Pennsylvania
Department of
Environmental Protection

MEMO

RE Response to Comments, Protests, and Testimony
MarkWest Liberty Midstream & Resources, LLC – Harmon Creek Gas Plant
Smith Township, Washington County
AUTH 1514603 APS 1130132 PFID 819388 Facility Status: Synthetic Minor
AUTH 1471222 APS 1066962 PFID 819388 Facility Status: Major (*Application Replaced*)

Figure 1:

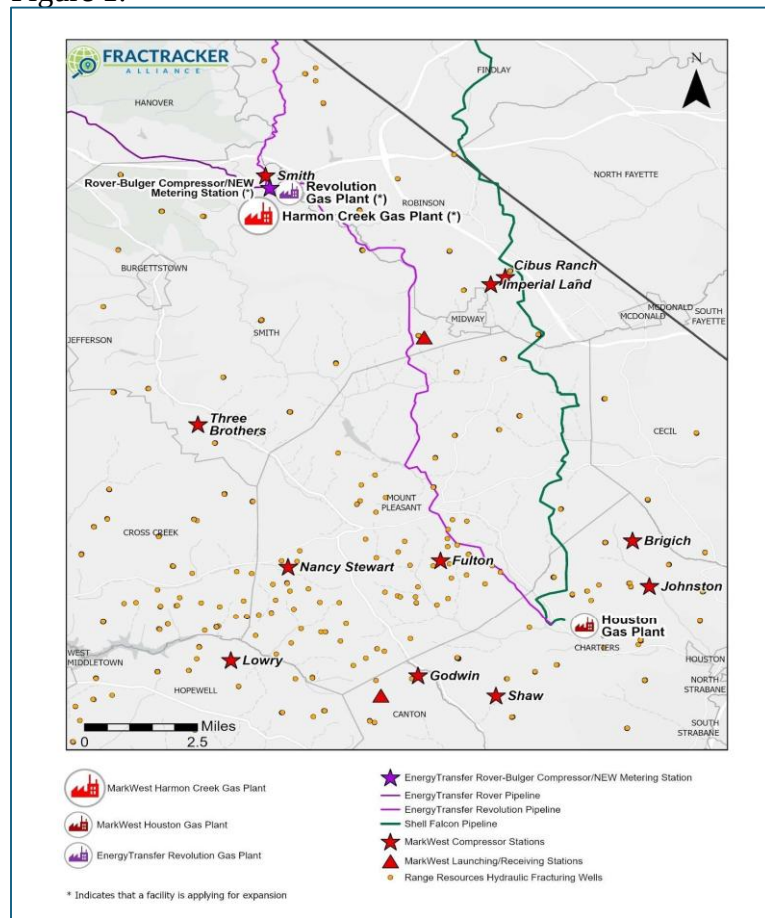
The Harmon Creek III expansion and facility are in an environmental justice area that is already saturated with a profusion of oil and gas industrial sites, many of which are connected, yet DEP failed to conduct or include an analysis of whether the Harmon Creek facility should be aggregated as a single source with any of the very nearby pollution sources. A notable example is the Harmon Creek Meter Station, which recently applied for an expansion with FERC and will directly connect with this facility. The Harmon Creek Meter Station is on the same road as Harmon Creek – Point Pleasant Road. The documents submitted to FERC regarding the meter station's expansion are available through FERC's website. See Rover Pipeline LLC Notice of Application and Establishing Intervention Deadline Rover-Bulger CS and Harmon Creek MS Expansion Project, Docket No. CP25-12-000 (Nov. 21, 2024), <https://www.federalregister.gov/documents/2024/11/21/2024-27144/rover-pipeline-llc-notice-of-application-and-establishing-intervention-deadline>.

For a map showing just some of the nearby oil and gas facilities, please see Figure 1, created by FracTracker Alliance.

RESPONSE: The Department inadvertently omitted a *Source/Facility Determination*, which evaluates source aggregation, from its review memo for the Harmon Creek Cryo III/DeEthanizer II project. The *Source/Facility Determination* is provided below.

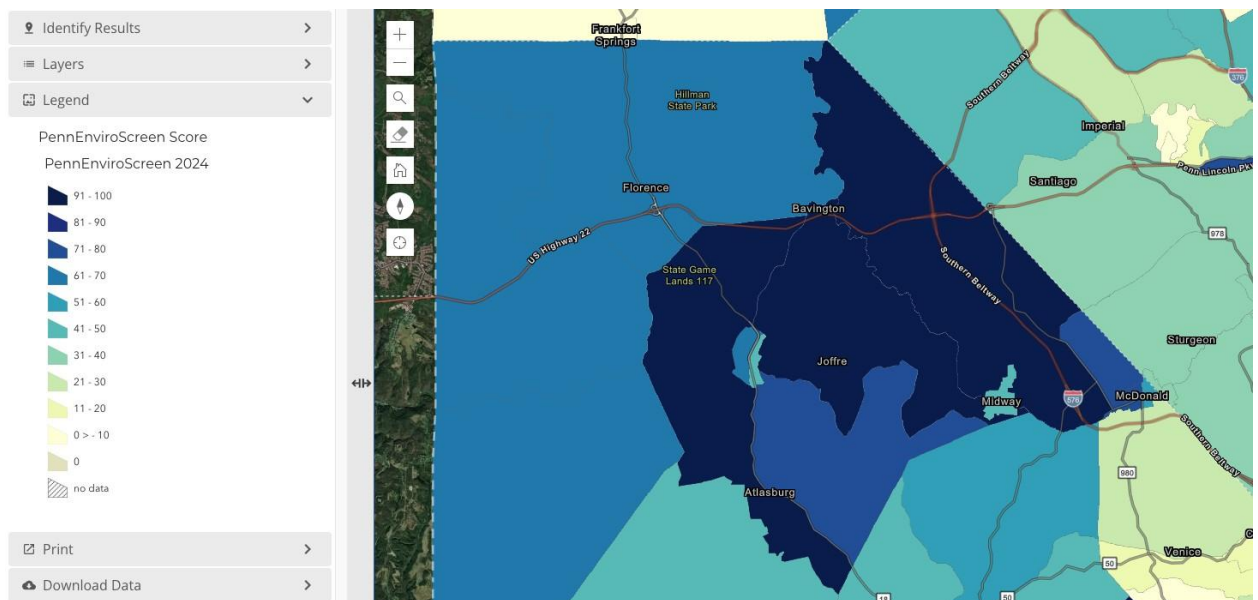
102. **COMMENT:** MarkWest must reapply for a Title V permit. MarkWest did not apply for a Title V permit because the expansion’s emissions are estimated to be just below the threshold that would require it. However, we understand that MarkWest initially planned to apply for a Title V permit but backtracked. Given this context and past experience with operators in the region, and past experiences of violations at this specific facility, it is very likely that MarkWest will emit above the threshold of their proposed permit, and, therefore, would require a Title V permit. Thus, the DEP should require MarkWest to apply for a Title V permit now rather than later to better protect this community.

RESPONSE: See the Department’s Responses to Comments 43, 44, 45, 46, 47, and 49.
